Planning Proposal for 137 Brisbane Grove Rd, Goulburn (REZ/0005/2121) (PP_2021_7390)

ATTACHMENT 1 – DETAIL

Map 1. SLWCA Unsewered Residential development (lots 4,000 m² to 2 ha) for Brisbane Grove Rd Goulburn

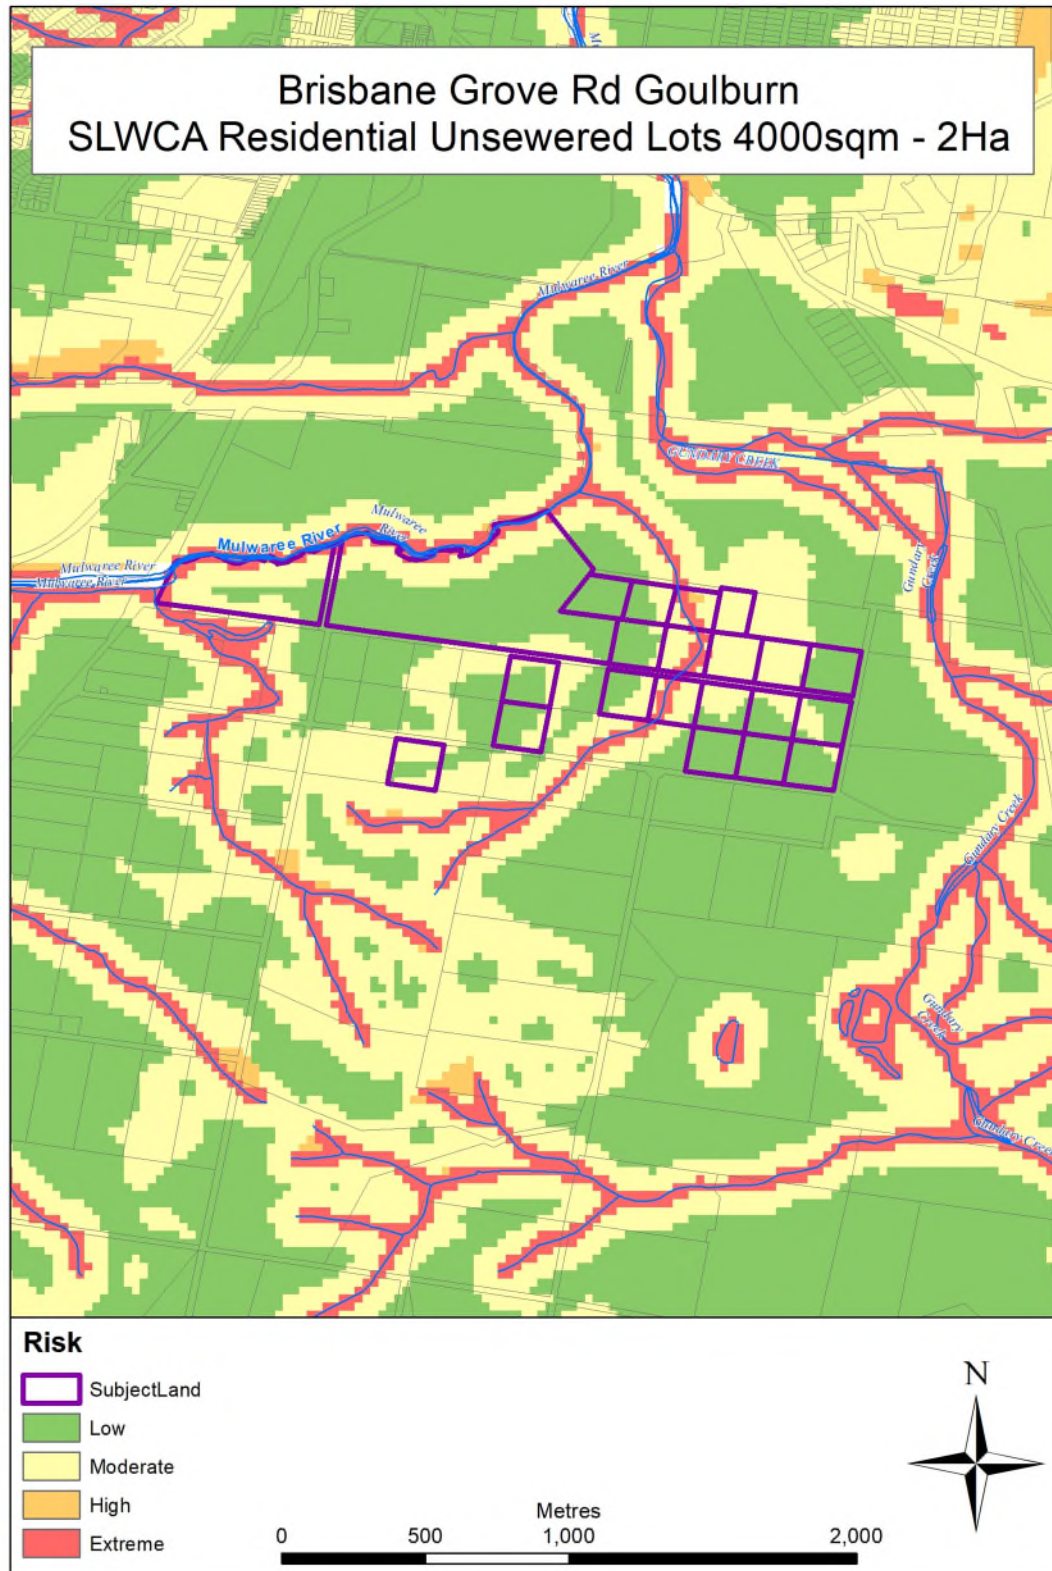
WaterNSW has prepared a Strategic Land and Water Capability Assessment (SLWCA) for the site. The most applicable SLWCA is for unsewered residential lots (4,000 sqm – 2 ha; Attachment 2). The SLWCA shows that the water quality risk to the site varies from LOW to EXTREME. The areas

classified as EXTREME are associated with the Mulwaree River and tributary watercourse. Most of the site carries a LOW to MODERATE water quality risk. Areas of EXTREME risk have a VERY LOW capability. Areas of LOW risk generally have a HIGH capability for unsewered development whereas areas of MODERATE risk have a MODERATE capability. We encourage unsewered development to be located in areas of LOW to MODERATE risk.

Please note that the variables influencing the outputs of the SLWCAs include distance to watercourses but do not include flooding risk. Also, as indicated earlier, there appears to be local drainage features in the north-west of the site which also need to be taken into account as a site constraint.
